Dixie-Narco®

Service Bulletin # _____ Date: September 23, 1983 Revised: October 10, 1983

MODELS: DNCB 630/360-5 & 6
DNCB 630T/360-5 & 6

SUBJECT: Replacement Refrigeration Systems.
Model 600
Model 600T

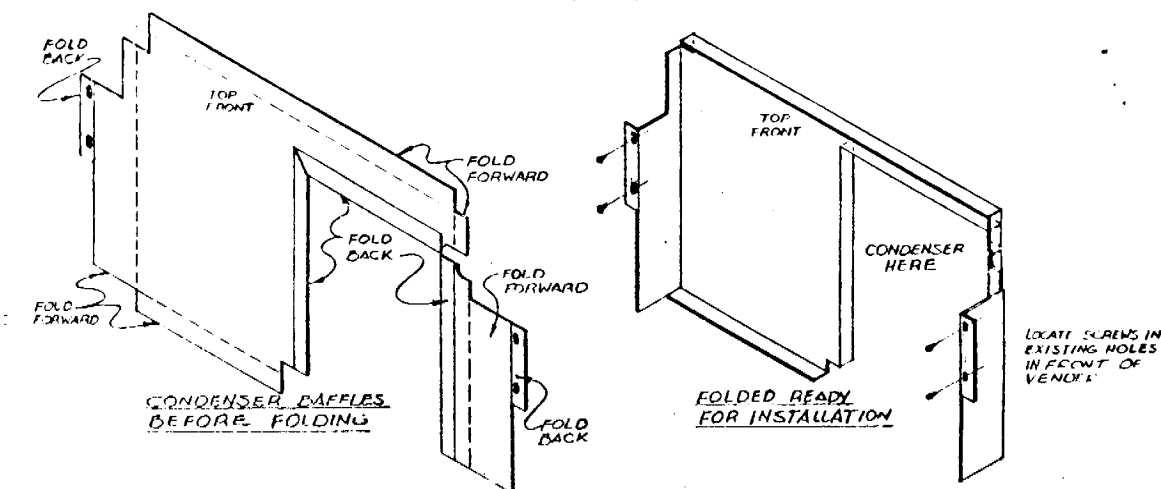
REASON: On production model venders, it was necessary to move the system approximately 1 inch to the left to provide more clearance.

INSTALLATION: When installation of the replacement 1/2 HP refrigeration system is made it will be necessary to relocate the condensate pan approximately 1 inch to the left.

Since this brought about a change in the condenser baffles, new baffles which must be installed are included with the system.

1	C905,800,480.01	Baffle Right Side
1	D905,800,440.11	Baffle Left Side
